The Santa Clara Valley Transportation Authority (VTA) has prepared this Supplemental Environmental Impact Report (SEIR) in accordance with the California Environmental Quality Act (CEQA), Public Resources Code 21000 et seq.; and the CEQA Guidelines, California Administrative Code, 15000 et seq. Per CEQA Guidelines Section 15163(2)(b), a supplement to an EIR “need contain only the information necessary to make the previous EIR adequate for the project as revised.”

The SEIR updates information presented in the *Silicon Valley Rapid Transit Corridor-BART Extension to Milpitas, San Jose and Santa Clara - Final Environmental Impact Report* (November 2004). The VTA Board of Directors certified the Final Environmental Impact Report (FEIR) in December 2004 in accordance

DESIGN CHANGES

Figure 1.3-1: Design Changes in Fremont

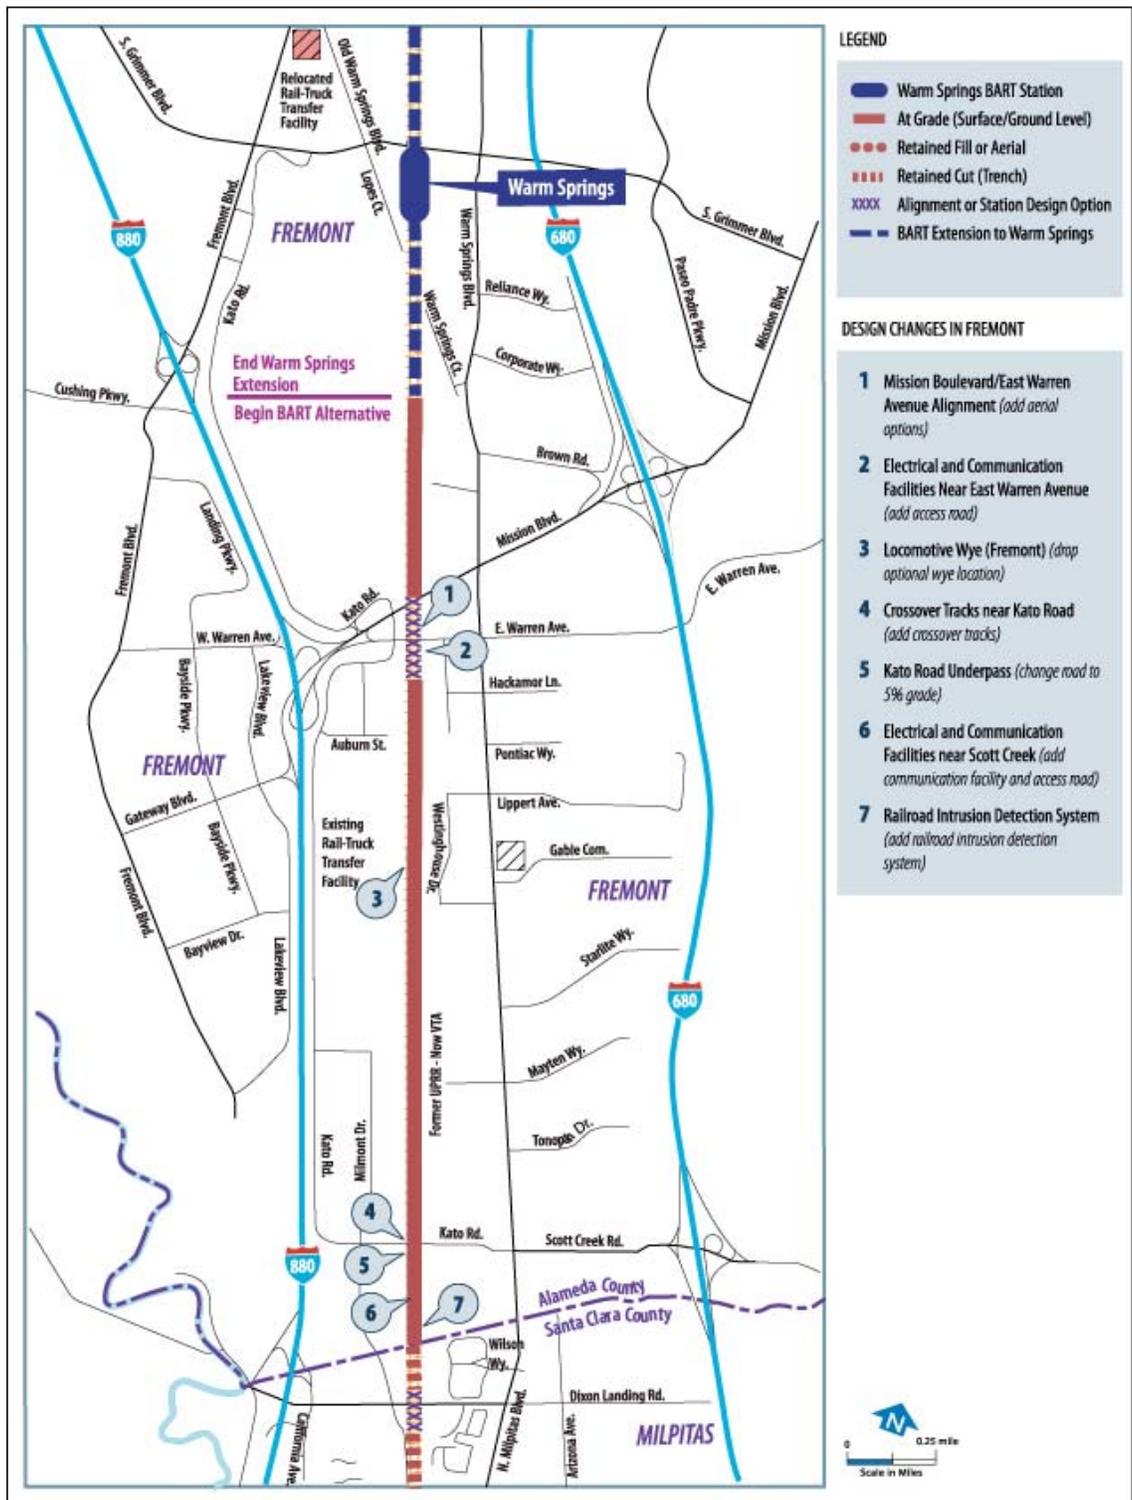
Design changes in Fremont include: the addition of two aerial alignment options from north of Mission Boulevard to East Warren Avenue; the addition of electrical facilities; the identification of access ease-

ments/roads; the elimination of a locomotive wye option; the addition or relocation of crossover tracks; a slight modification to the configuration of the Kato Road underpass; and the inclusion of a railroad intrusion detection system, which would also be installed in the cities of Milpitas, San Jose, and Santa Clara. The design changes are listed in Table 1.3-1 and shown in Figure 1.3-1. A full description of each design change in Fremont is provided in Section 3.2.1.

Design Change 1. Mission Boulevard/ East Warren Avenue Alignment.

- ❑ In the FEIR, the BART alignment would travel at grade over the Mission Boulevard underpass. South of Mission Boulevard, the BART alignment would be at grade and other agencies would reconstruct East Warren Avenue as a roadway underpass.
- ❑ In the SEIR, there are three options for the BART alignment from Mission Boulevard to East Warren Avenue. One option is the at grade configuration already analyzed in the FEIR. The two additional options include an Aerial Option and an Aerial East Option where BART would transition into an aerial configuration from just north of Mission Boulevard to south of East Warren Avenue. Under the aerial options, no improvements would be required for East Warren Avenue to accommodate the BART alignment.

Design Change 2. Electrical and Communication Facilities near East Warren Avenue.

- ❑ In the FEIR, a traction power substation and train control building are located south of East Warren Avenue and east of the railroad ROW; however, access to the site is not discussed.
- ❑ In the SEIR, this location is retained with an access easement/road connecting the site with Mission Falls Court.

Design Change 3. Locomotive Wye (Fremont).

- ❑ In the FEIR, one option for the locomotive wye would be located in Fremont on an undeveloped parcel on the west side of the corridor, approximately 0.8 miles south of East Warren Avenue. The other option would be located in Milpitas.

- In the SEIR, the Fremont wye location option is eliminated. The option in Milpitas is retained, plus an additional option (see Design Change 13).

Design Change 4. Crossover Tracks near Kato Road.

- In the FEIR, there are no crossover tracks north or south of Kato Road.
- In the SEIR, crossover tracks would be located both north and south of Kato Road.

Design Change 5. Kato Road Underpass.

- In the FEIR, the BART alignment would cross at grade on a new bridge structure over Kato Road, which would be reconstructed as a roadway underpass. The slope of Kato Road would be an 8 percent grade.
- In the SEIR, Kato Road would also be constructed as a roadway underpass. However, the slope would be a 5 percent grade making the profile of Kato Road slightly longer.

Design Change 6. Electrical and Communication Facilities near Scott Creek.

- In the FEIR, a traction power substation is located south of Scott Creek and west of the railroad ROW.
- In the SEIR, this location is retained with an access easement/road connecting the site with Milmont Drive. The site would also include a train control building.

Design Change 7. Railroad Intrusion Detection System.

- In the FEIR, a railroad intrusion detection system is not included.
- In the SEIR, this system would be installed along the railroad corridor in Fremont.¹

Figure 1.3-2: Design Changes in Milpitas

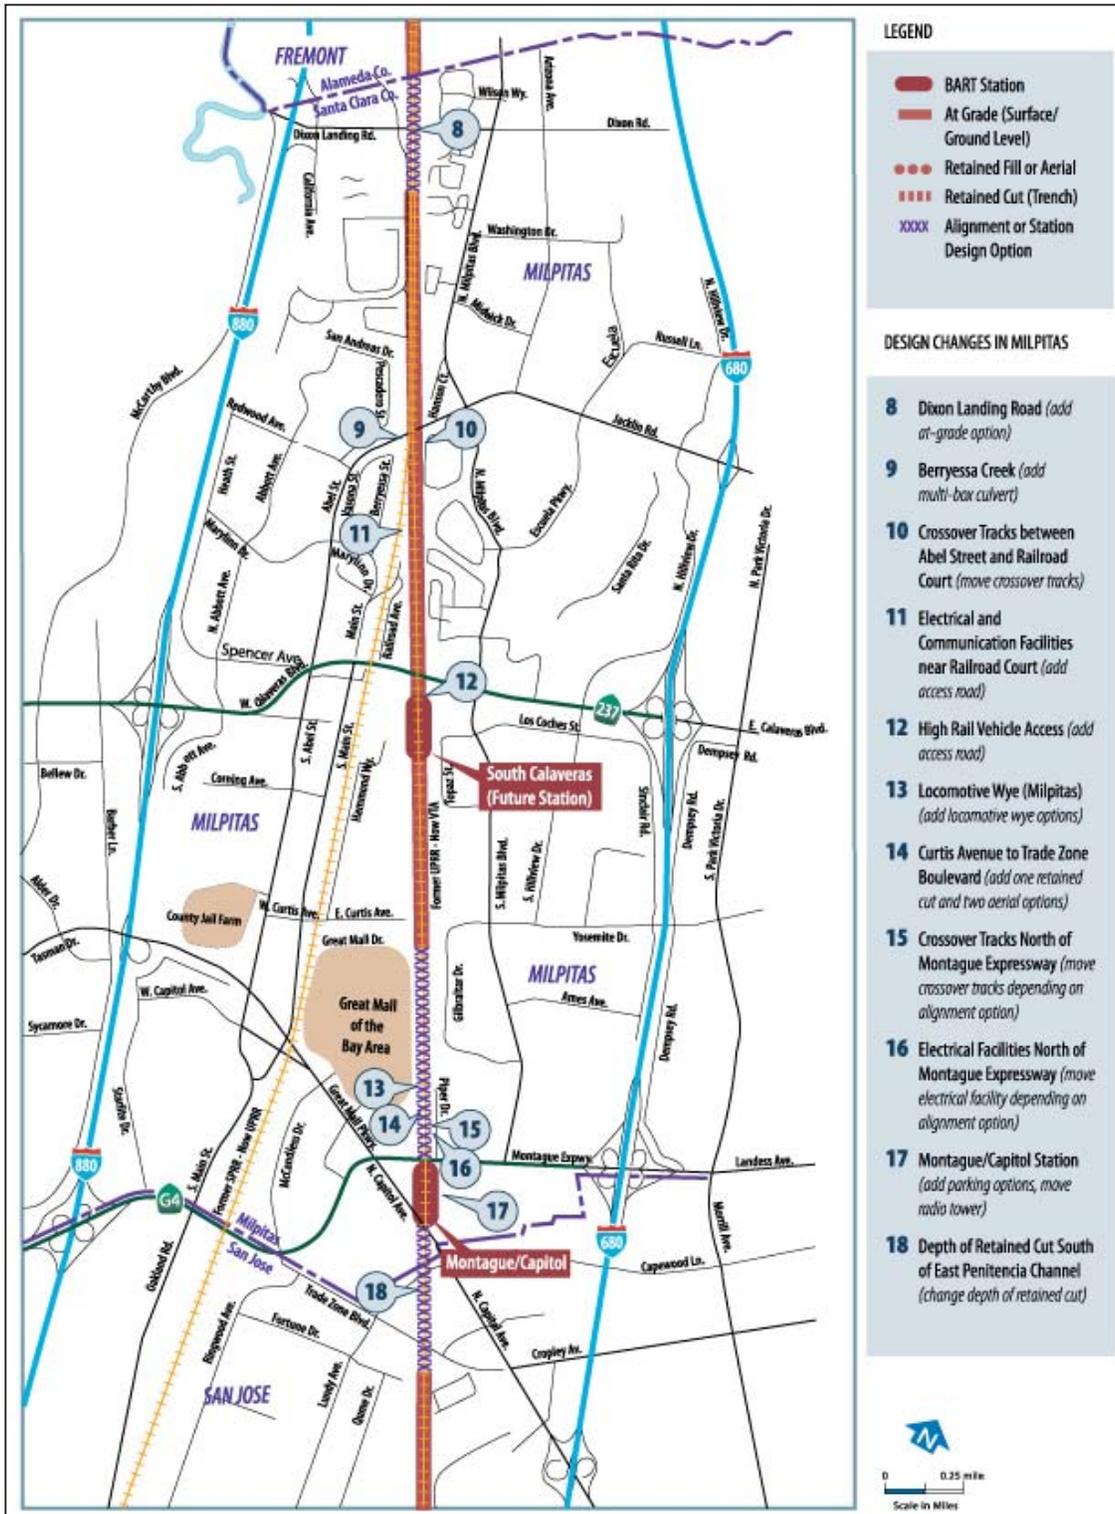
Design changes in Milpitas include: the addition

of one alignment option at Dixon Landing Road; the addition or relocation of crossover tracks; the addition or relocation of electrical and communication facilities; the identification of access easements/roads; the potential elimination of a locomotive wye; the addition of three alignment options south of Curtis Avenue; and the reconfiguration of Project features at the Montague/Capitol Station. The railroad intrusion detection system described for Fremont would also be installed in Milpitas. The design changes are listed in Table 1.3-2 and shown in Figure 1.3-2. A full description of each design change in Milpitas is provided in Section 3.2.2.

Design Change 8. Dixon Landing Road Alignment.

- In the FEIR, the BART alignment would travel below grade in a retained cut under Dixon Landing Road. Dixon Landing Road would be supported above BART on a new roadway structure that would remain at grade.
- In the SEIR, there are two options for the BART alignment at Dixon Landing Road. One option is the retained cut configuration already analyzed in the FEIR. In addition, an At Grade Option is included. Under this option, Dixon Landing Road would be reconstructed as a new roadway underpass with BART passing at grade over the roadway on a new bridge structure. An adjacent cross street to the west of the railroad ROW, Milmont Drive, would be lowered due to the slope of Dixon Landing Road.

Design Change 9. Berryessa Creek.

- In the FEIR, BART would pass over Berryessa Creek on a new 100-foot-long bridge.
- In the SEIR, BART would cross over Berryessa Creek on a new double box culvert.

Design Change 10. Crossover Tracks between Berryessa Creek and Railroad Court.

- ❑ In the FEIR, crossover tracks would be located near Railroad Court.
- ❑ In the SEIR, the crossover tracks located near Railroad Court are eliminated. Instead, crossover tracks would be located to the north towards the Berryessa Creek crossing.

Design Change 11. Electrical and Communication Facilities near Railroad Court.

- ❑ In the FEIR, a high voltage substation, traction power substation, switching station, and train control building would be located north of Railroad Court on the west side of the railroad ROW; however, access to the site is not discussed.
- ❑ In the SEIR, this location is retained with an access easement/road connecting the site with Railroad Court.

Design Change 12. High Rail Vehicle Access.

- ❑ In the FEIR, a high rail vehicle access point would be located south of Calaveras Boulevard (State Route 237).
- ❑ In the SEIR, this location is retained with an access easement/road connecting to Railroad Avenue.

Design Change 13. Locomotive Wye (Milpitas).

- ❑ In the FEIR, one option for the locomotive wye would be located north of Montague Expressway and east of the railroad ROW. The other option would be located in Fremont.
- ❑ In the SEIR, there are two options for the locomotive wye. One option includes constructing a new wye in Milpitas in the same location as that described in the FEIR. The second option considered is no wye at all. There is no longer a wye option in Fremont.

Design Change 14. Curtis Avenue to Trade Zone Boulevard.

- ❑ In the FEIR, the BART alignment would be in a long retained cut starting from South of Curtis Avenue and ending south of Trade Zone Boulevard. BART would continue in a

retained cut past the Great Mall and would pass beneath Montague Expressway, Capitol Avenue, and Trade Zone Boulevard, each of which would be supported above BART on new roadway structures. The retained cut configuration would allow a UPRR freight track to cross the BART alignment on a bridge to gain access to a new locomotive wye and an existing spur track that serves three businesses east of the BART alignment.

- ❑ In the SEIR, there are four options for the BART alignment from south of Curtis Avenue. One option is the long retained cut configuration already analyzed in the FEIR. The three additional options include a Retained Cut Short Option, Aerial Long Option, and Aerial Short Option. The Aerial Long Option would also allow the UPRR freight track to cross the BART alignment to gain access to industries and the potential wye east of the railroad ROW. However, the two short options do not allow for this crossing. Under either retained cut option, Montague Expressway, Capitol Avenue, and Trade Zone Boulevard would require the same improvements as described in the FEIR. Under either aerial option, no improvements would be required for Montague Expressway or Trade Zone Boulevard. However, Capitol Avenue would be reconstructed below grade.

Design Change 15. Crossover Tracks North of Montague Expressway.

- ❑ In the FEIR, crossover tracks would be located north of Montague Expressway in a retained cut configuration.
- ❑ In the SEIR, the crossover tracks would remain in the same location and configuration under the Retained Cut Long Option for the alignment south of Curtis Avenue (see Design Change 14). Under the Aerial Long Option, the tracks would be located slightly farther north and on the aerial structure. Under the Retained Cut Short Option, the crossover tracks would be located in the same general location as under the Aerial Long Option but in an at grade configuration. Under the Aerial Short Option, the crossover tracks would be located the farthest north.

Design Change 16. Electrical Facilities North of Montague Expressway.

- ❑ In the FEIR, a traction power substation would be located north of Montague Expressway and east of the railroad ROW.
- ❑ In the SEIR, this substation would remain in this location under the Retained Cut Long and Aerial Long options for the alignment south of Curtis Avenue (see Design Change 14). However, under the Retained Cut Short and Aerial Short options, this substation would be located immediately north of the Piper Drive cul-de-sac and east of the railroad ROW.

Design Change 17. Montague/Capitol Station.

- ❑ In the FEIR, a three to five level parking structure would be constructed on 3.4 acres at the north end of the station area. A radio tower would be located at the northwest corner of the parking structure, either alongside or on top of the structure. A bus transit center would be located to the south of both the parking structure and South Milpitas Boulevard, which would be extended into the station area from Montague Expressway to Capitol Avenue.

- ❑ In the SEIR, there are two new options for parking in the station area. Under the Parking Structure with Surface Parking Option, a four to eight level parking structure on two acres would be in the same general location as described in the FEIR. New property acquisition would include the areas east and west of Gladding Court to be designated as surface parking and/or future transit facilities. Additional surface parking and/or future transit facilities would be located as needed within the station area. Under the Surface Parking Option, the area where the parking structure would be located under the Parking Structure Option would be for surface parking and/or future transit facilities. The areas east and west of Gladding Court would be acquired and used for surface parking and/or future transit facilities. Additional surface parking and/or future transit facilities would be located within the station area. Under either parking option, the bus transit center would be located north of the South Milpitas Boulevard extension. The radio tower would be located west of the railroad ROW and south of South Milpitas Boulevard.

The configuration of the station would vary depending on the option chosen for the alignment south of Curtis Avenue (Retained Cut Long or Short Options, Aerial Long or Short Options – see Design Change 14). If either retained cut option were chosen, the station would include two side platforms, as described in the FEIR. If either aerial option were chosen, the station would include a center platform in an aerial configuration.

Design Change 18. Depth of Retained Cut South of East Penitencia Channel.

- ❑ In the FEIR, the depth of the retained cut from south of East Penitencia Channel to Trade Zone Boulevard is approximately 30 feet below grade.
- ❑ In the SEIR, under the Retained Cut Long and Retained Cut Short options for the alignment south of Curtis Avenue (see Design Change 14), the depth is generally less than 30 feet. Along the shallowest portion of the retained cut, the depth is only 10 feet below grade.

Figure 1.3-3: Design Changes in San Jose

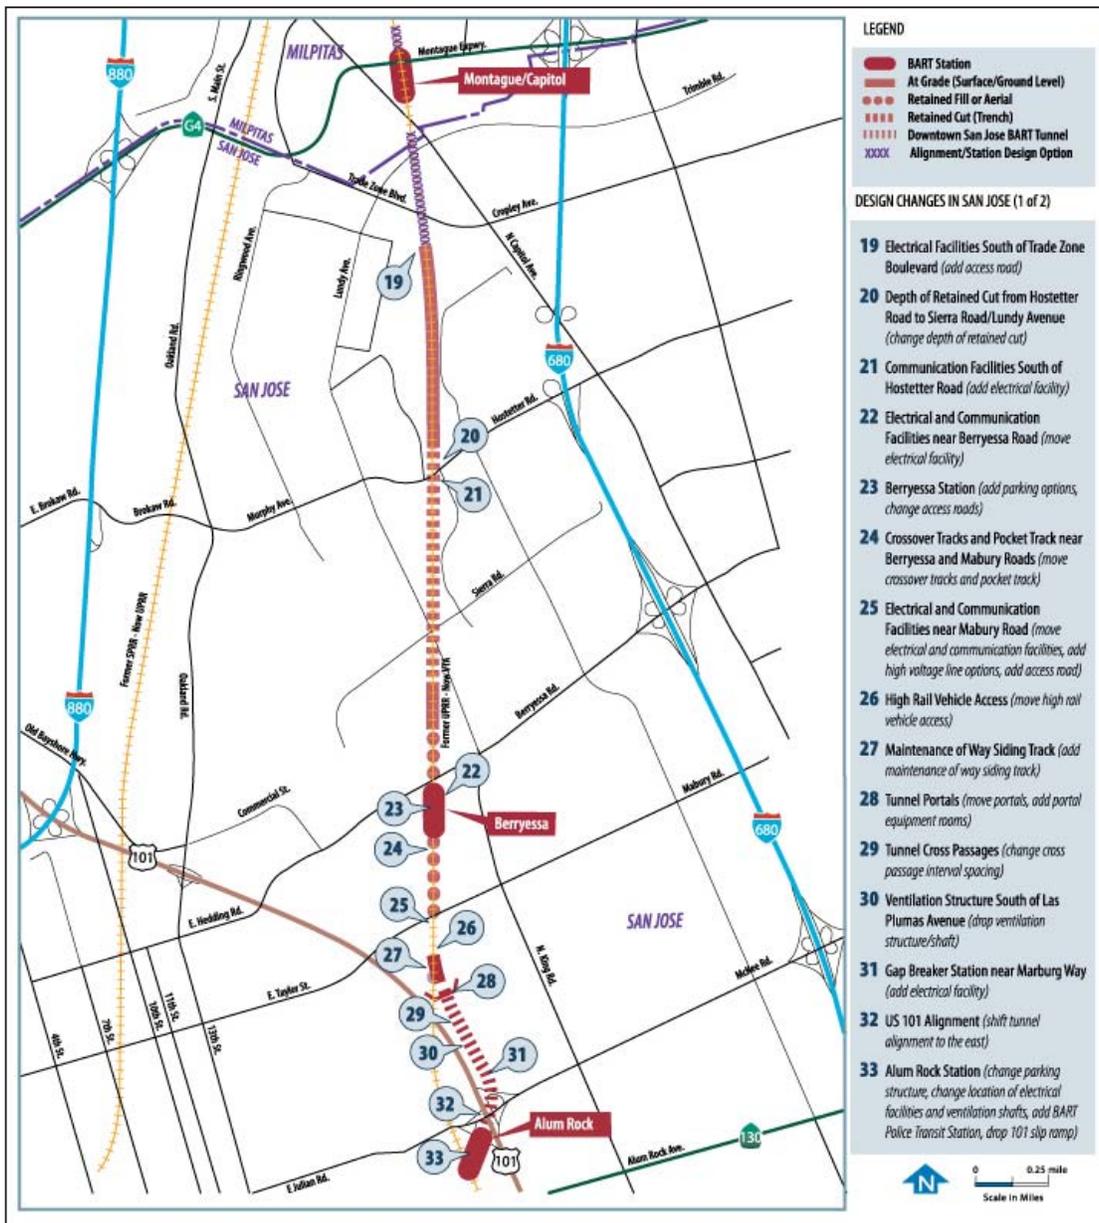
Design changes in San Jose include: the addition or relocation of electrical, communication, or ventilation facilities; the identification of access easements/roads; the adjustment in the depth of some of the retained cuts; the reconfiguration of Project features at the Berryessa, Alum Rock, and Diridon/Arena stations; the elimination of the Civic Plaza/SJSU and Market Street stations; the addition of the Downtown San Jose Station; the addition or relocation of crossover tracks; the modification of the tunnel alignment in some locations; and other minor changes. The railroad intrusion detection system described for Fremont would also be installed in San Jose (see Design Change 7). The design changes are listed in Table 1.3-3 and shown in Figures 1.3-3 and 1.3-4. A full description of each design change in San Jose is provided in Section 3.2.3. The yard and shops facility, which is partially located in San Jose but mostly located in Santa Clara, is discussed in Section 1.3.4 for design changes in Santa Clara.

Design Change 19. Electrical Facilities South of Trade Zone Boulevard.

- In the FEIR, a traction power substation is located south of Trade Zone Boulevard and west of the railroad ROW.
- In the SEIR, this location is retained with a two potential locations for an access easement/ road connecting the site with Qume Drive.

Design Change 20. Depth of Retained Cut from Hostetter Road to Sierra Road/Lundy Avenue.

- In the FEIR, the depth of the retained cut from north of Hostetter Road to south of Sierra Road/Lundy Avenue varies from approximately 20 to 50 feet below grade. The deepest portions are under the Hostetter Road and Sierra Road/Lundy Avenue overcrossings.
- In the SEIR, the depth varies from approximately 10 to 35 feet below grade.
